Building Permit Application

Permit No.: **B18002802**

Building Address: 13091 Williamfield Dr
City: Ellicott City State: MD Zip Code: 21042
Suite/Apt. #: _____ SDP/WP/BA #: _____
Subdivision: Rosemary Estates
Lot: 25 D Tax Map: 22 Parcel: 504

RE: Waiver Approval
13091 Williamfield Drive
Ellicott City, MD 21042

1st Floor Proposed

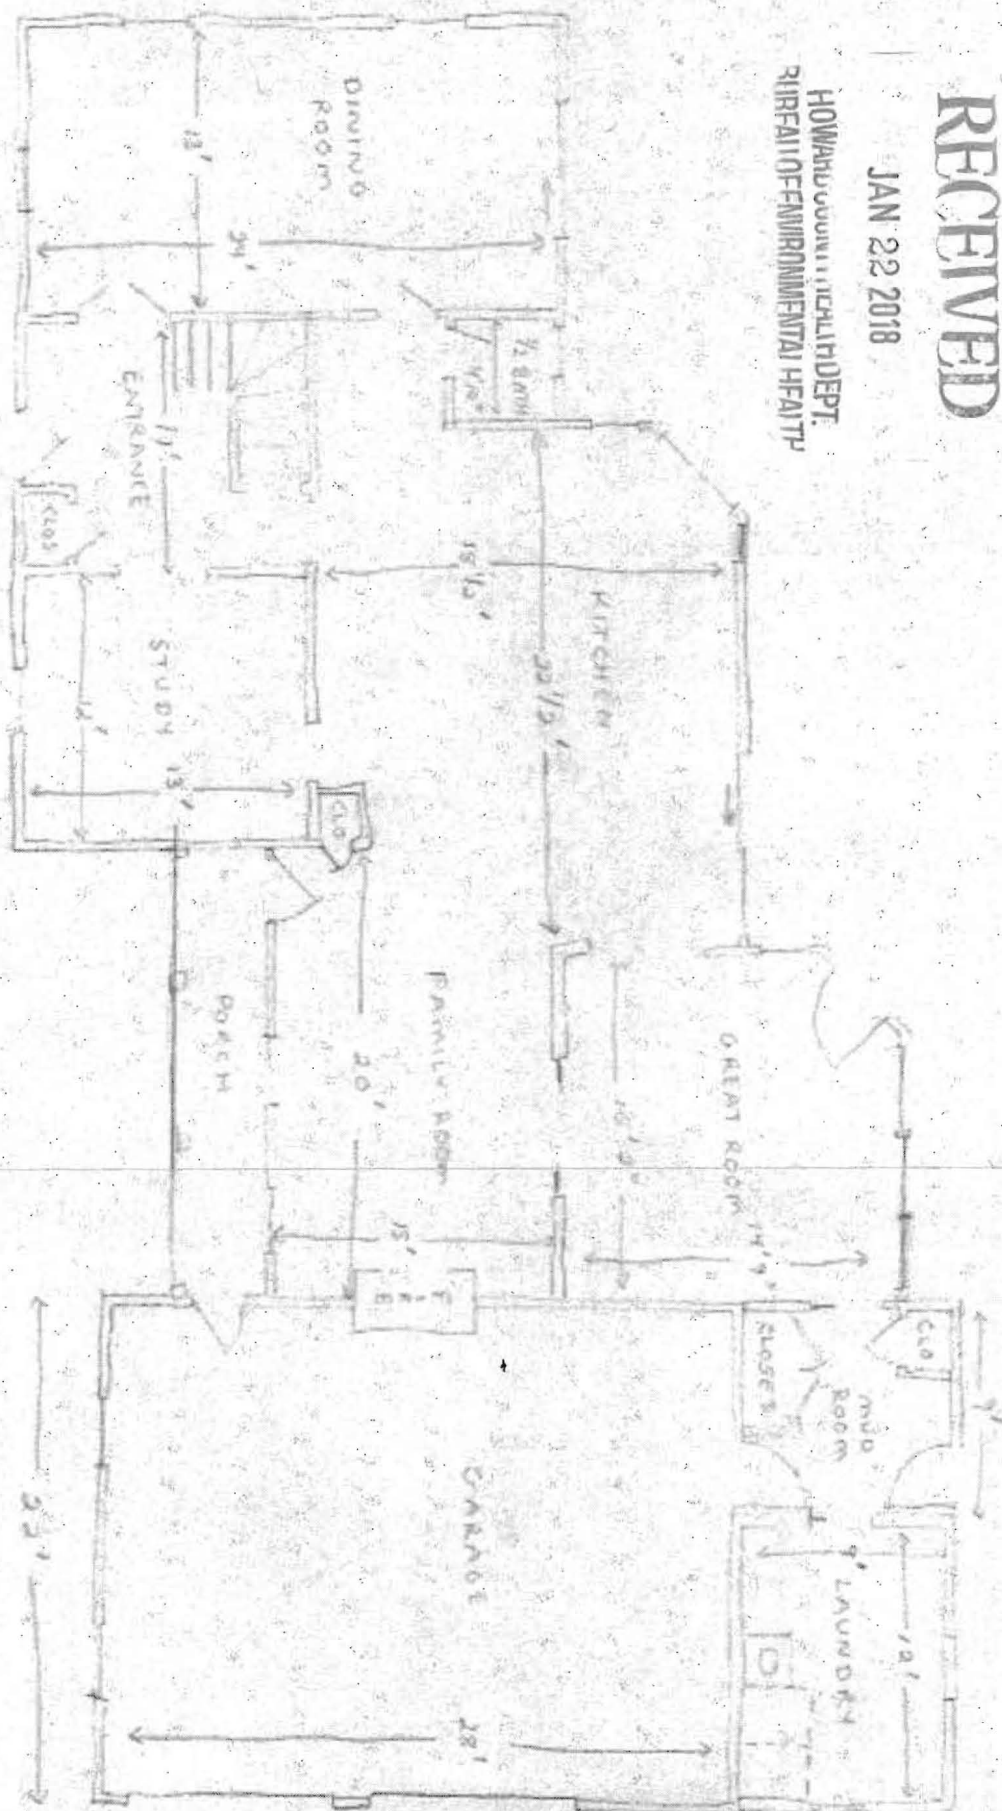
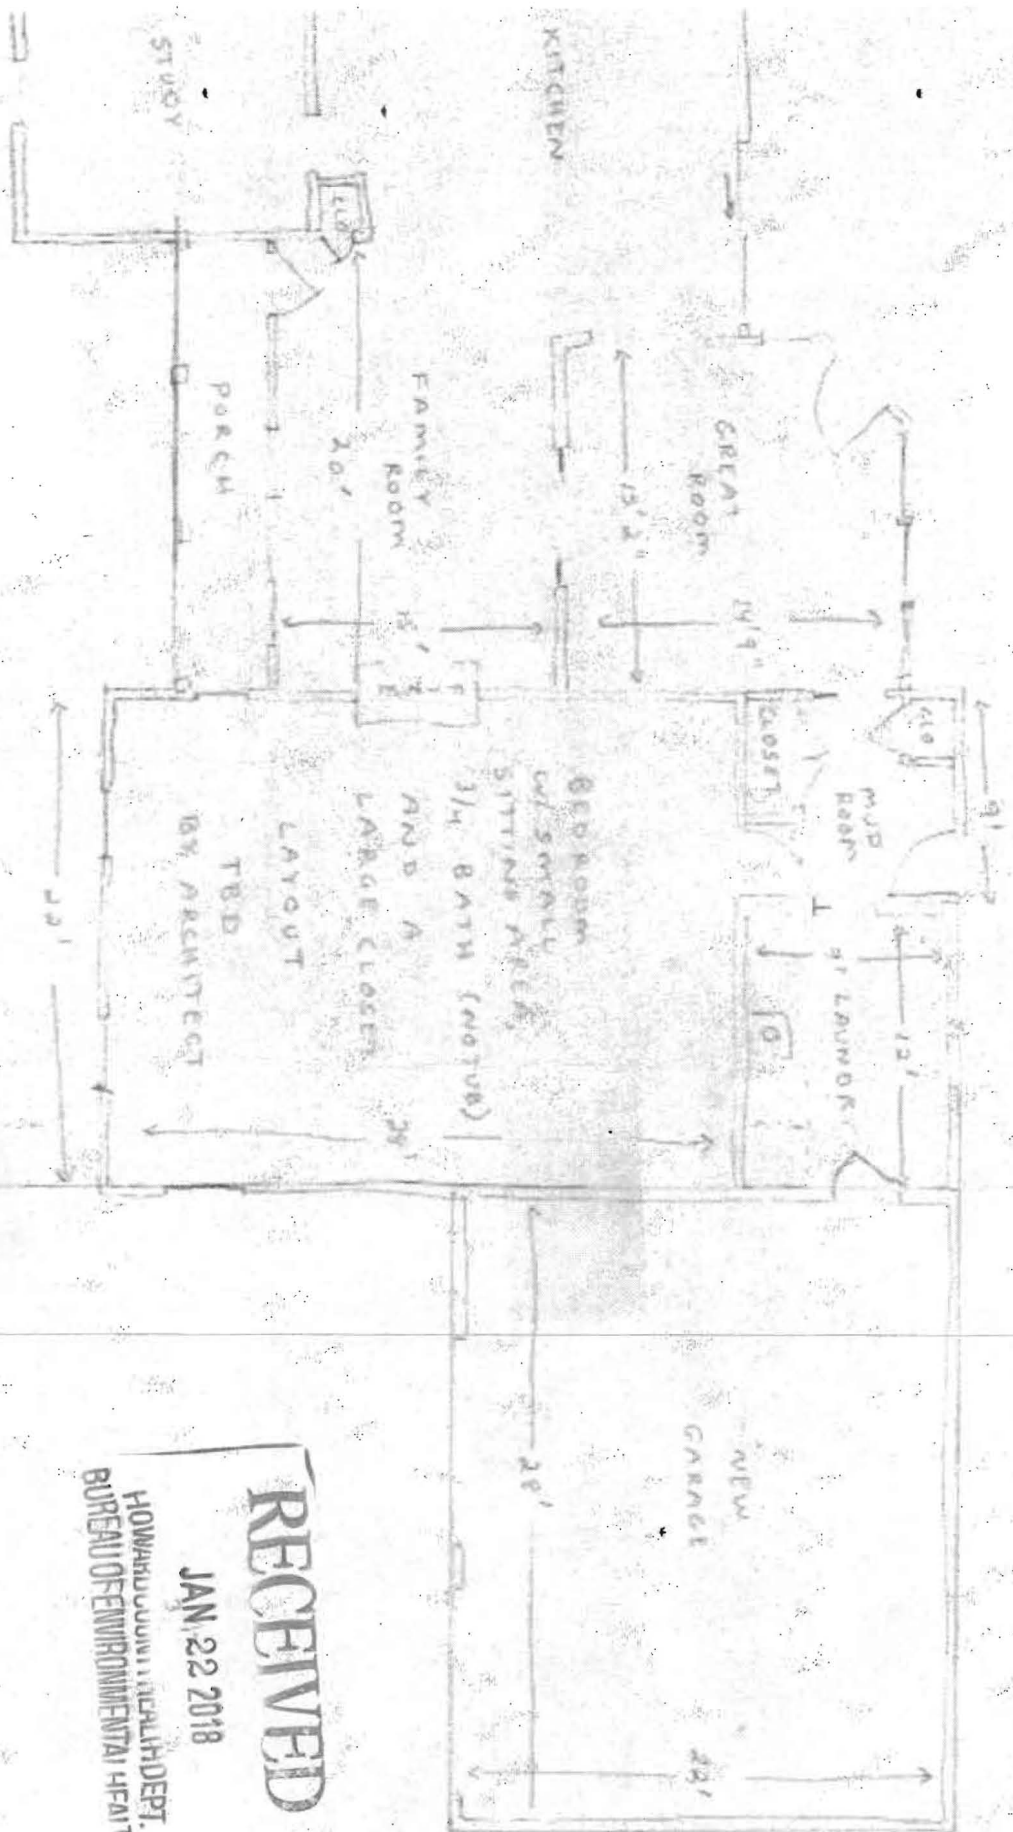
Hi Linda,
Mike has taken a look at the sketches and he needs clearer floor plans showing the existing house (all levels) and proposed rooms. The ones sent are hard to see and understand. You can send them straight my email and I will pass them along.

In order for us to complete our review of your waiver request letter we need to see floor plans of the existing house and proposed house. We need to see exactly how these changes are going to be installed. These floor plans do not have to be professionally done. These can be hand drawn and emailed directly to me. The list below is what we will need to see on the plans. I apologize for not mentioning this earlier as I was under the impression someone already contacted you about this. If you have any questions at all let me know.

This letter is being issued in response to your waiver request dated November 8, 2018. This department has approved the waiver based on the floor plans submitted on January 22, 2018 illustrating the alterations to the floor plan to eliminate a second story bedroom and maintain the existing bedroom count of four (4). The existing on-site sewage disposal system may be maintained as is and the requirement for a percolation certification plan has been waived. Any deviations from the proposed work illustrated on the building permit site plan and the proposed floor plan will be subject to further review by this department. Any future property improvements will likely require perc testing and a revised percolation certification plan.
